Addendum Date: May 13, 2024

CITY OF PENSACOLA, FLORIDA
ADDENDUM #1

**PENSACOLA INTERNATIONAL AIRPORT TIPPIN AVENUE PARKING
LOT PROJECT
Bid No. 24-028**

REVISED SCOPE OF WORK
ADDENDUM #1 – 5/10/2024

C-1

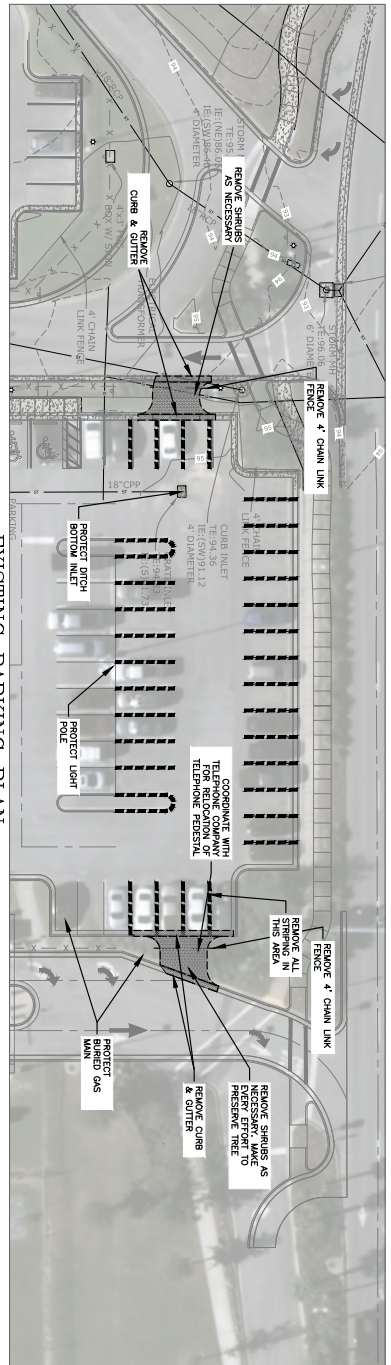
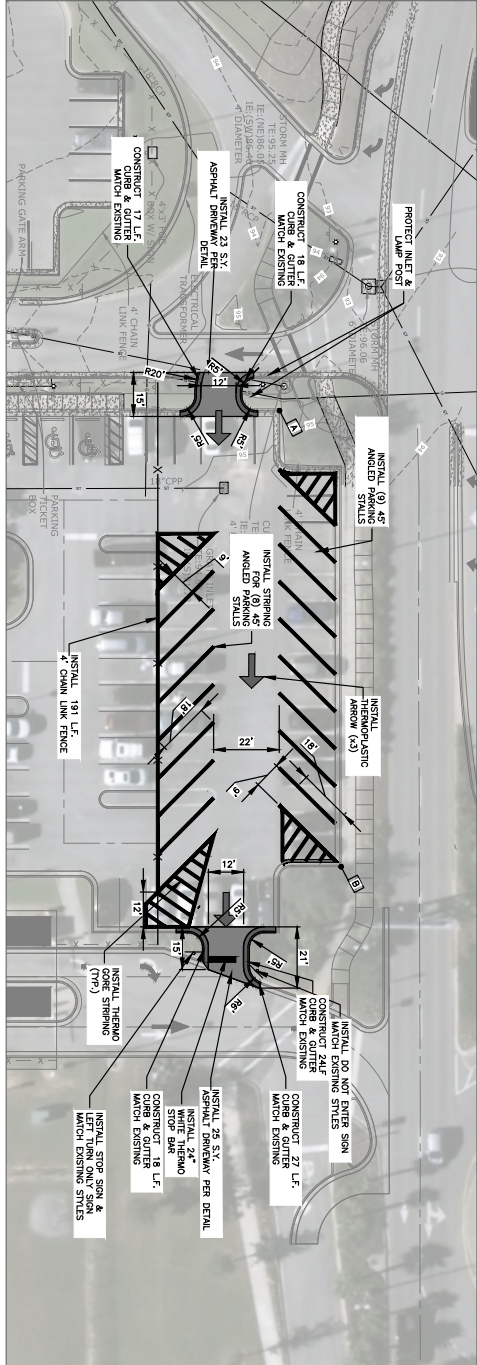
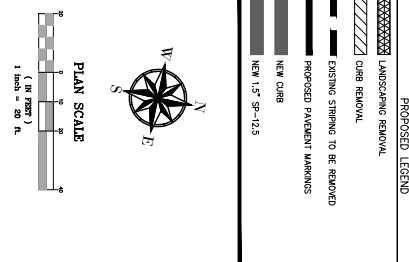
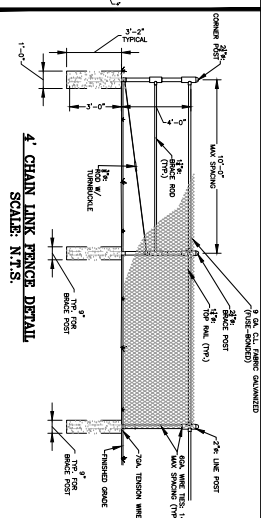
NEW BID ALTERNATE ITEMS: CELL PHONE LOT MODIFICATIONS = ADDITIVE ALT #2

A revised scope of work has been attached to this addendum to describe this bid alternate. In addition, the plans for this bid alternate work have been attached to this addendum. Finally, the bid tab has been modified to incorporate the line items associated with the Cell Phone Lot Modifications Bid Alternate

NOTE: EXISTING STRIPING REMOVAL SHALL BE INSTALLED AS COMPLETE REMOVAL OF EXISTING STRIPING TO EXPOSE EXISTING ASPHALT BENEATH STRIPES. ALL PROPOSED STRIPING SHALL BE THERMOPLASTIC. CURBS AND POSTS SHALL BE INSTALLED WITH EXISTING ASPHALT IN SOME AREAS. EVEN SO POSTS SHALL BE SET IN ACCORDANCE WITH THE DETAIL AND ASPHALT RESTORED AROUND NEW FENCE POSTS. EXISTING IRREGULAR STRIPING SHALL BE REMOVED IN SUCH A WAY AS TO ACCOMMODATE NEW STRIPING. ALL STRIPING SHALL BE REMOVED COMPLETELY. IRREGULAR COVERAGE FOR EXISTING STRIPING SHALL BE RESTORED WITH LANDSCAPING/GROUND COVER TO MATCH THE PRE-EXISTING CONDITIONS. REMOVE AND STORPILE ALL EXISTING WHEEL STOPS WITHIN LIMITS OF CONSTRUCTION. REINSTALL WITHIN ANGLED STALLS PER DETAIL. BELOW SHOULD BE REMOVED AND RESTORED WITHIN ANGLED STALLS PER DETAIL. ALL EXISTING WHEEL STOPS AND BENCHMARKS SHALL BE REMOVED AND RESTORED WITHIN ANGLED STALLS PER DETAIL. ALL EXISTING WHEEL STOPS SHALL BE RESTORED WITHIN ANGLED STALLS PER DETAIL. ALL EXISTING WHEEL STOPS SHALL BE RESTORED WITHIN ANGLED STALLS PER DETAIL. ALL EXISTING WHEEL STOPS SHALL BE RESTORED WITHIN ANGLED STALLS PER DETAIL.
